Access Compliance Report

Public Rights-of-Way

(Curb Ramps)

Intersection ID: 12937	Main Street: E_W_T_HARRIS_BV	Cross Street: HICKORY_GROVE_RD	Location: SW
ADA ID: 542434D61550	Ramp Type: Perp	Initial Pass/Fail: Fail	Overall Compliance: No
Severity Score: 33.75			
Codes/Mitigation Info/Possible Solution		Field Measurements/Component Compliance

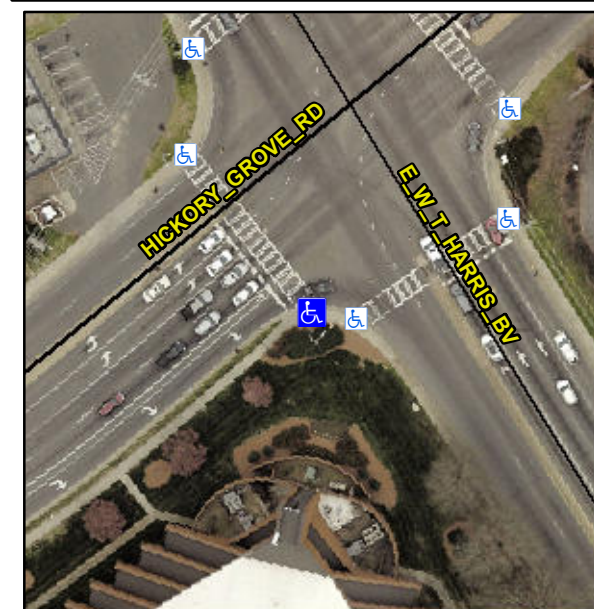
Not Found, R304.5.1, R304.2.2

Compliance	Description	Data	Compliance	Description	Data
N/A	Ramp Length (in)	25.0	No	Ramp Slope (%)	14.3
No	Ramp Width (in)	44.0	Yes	Ramp XSlope (%)	0.3
N/A	Flare Type LT	N/A	N/A	Flare Type RT	N/A
N/A	Flare Slope LT (%)	N/A	N/A	Flare Slope RT (%)	N/A
N/A	Flare Traversable LT?	N/A	N/A	Flare Traversable RT?	N/A
N/A	Landing Length (in)	N/A	N/A	DWS Provided?	N/A
N/A	Landing Width (in)	N/A	N/A	DWS Contrast?	N/A
N/A	Landing Slope (%)	N/A	N/A	DWS Length (in)	N/A
N/A	Landing X Slope (%)	N/A	N/A	DWS Full Width?	N/A
N/A	Landing Curb? (Y/N)	N/A	N/A	DWS Offset (in)	N/A
N/A	Shared Landing?	N/A			
N/A	Gutter Ponding?	N/A	N/A	Gutter Slope (%)	N/A
N/A	Gutter Lip Ht (in)	N/A	N/A	Gutter X Slope (%)	N/A
N/A	Painted X Walk1?	Yes	N/A	Painted X Walk2?	N/A
	X Walk 1 Direction	To NW		X Walk 2 Direction	N/A
N/A	X Walk 1 Width (in)	119.5	N/A	X Walk 2 Width (in)	N/A
	X Walk 1 Slope (%)	2.2		X Walk 2 Slope (%)	N/A
	X Walk 1 X Slope (%)	0.1		X Walk 2 X Slope (%)	N/A

Remove & Replace Entire Ramp.
